**BEFORE  
THE PUBLIC UTILITIES COMMISSION OF OHIO**

In the Matter of the Filing by Ohio Edison Company, The Cleveland Electric Illuminating Company, and The Toledo Edison Company of a Grid Modernization Business Plan	)	
	)	
	)	Case No. 16-481-EL-UNC
	)	
	)	
In the Matter of the Filing by Ohio Edison Company, The Cleveland Electric Illuminating Company and The Toledo Edison Company Application for Approval of a Distribution Platform Modernization Plan	)	
	)	
	)	Case No. 17-2436-EL-UNC
	)	
	)	
	)	
In the Matter of the Application of Ohio Edison Company, The Cleveland Electric Illuminating Company and The Toledo Edison Company to Implement Matters Relating to the Tax Cuts and Jobs Act of 2017	)	
	)	
	)	Case No. 18-1604-EL-UNC
	)	
	)	
	)	
In the Matter of the Application of Ohio Edison Company, The Cleveland Electric Illuminating Company, and The Toledo Edison Company for Approval of a Tariff Change	)	
	)	
	)	Case No. 18-1656-EL-ATA
	)

**DIRECT TESTIMONY OF CURT VOLKMANN  
ON BEHALF OF  
ENVIRONMENTAL LAW & POLICY CENTER,  
NATURAL RESOURCES DEFENSE COUNCIL, AND  
OHIO ENVIRONMENTAL COUNCIL**

January 17, 2019

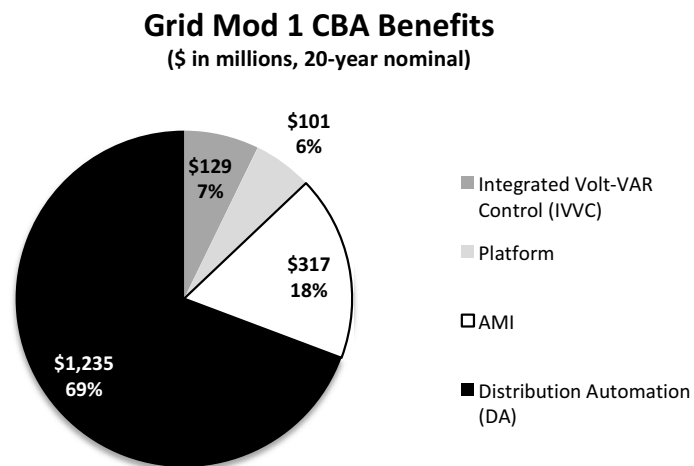
12 A. The Companies attribute \$1,235 million (20 year nominal) or 69% of the total  
13 nominal Benefits to Distribution Automation or DA. The diagram below  
14 shows the sources of Benefits in the Companies' Grid Mod 1 CBA.

16 Of the \$1,235 million of DA Benefits, the Companies attribute \$803 million  
17 (45% of the total Benefits) to improved reliability from DA during major

1 storms/events, and \$432 million (24% of the total Benefits) to improved  
2 reliability from DA excluding major storms/events.<sup>8</sup>
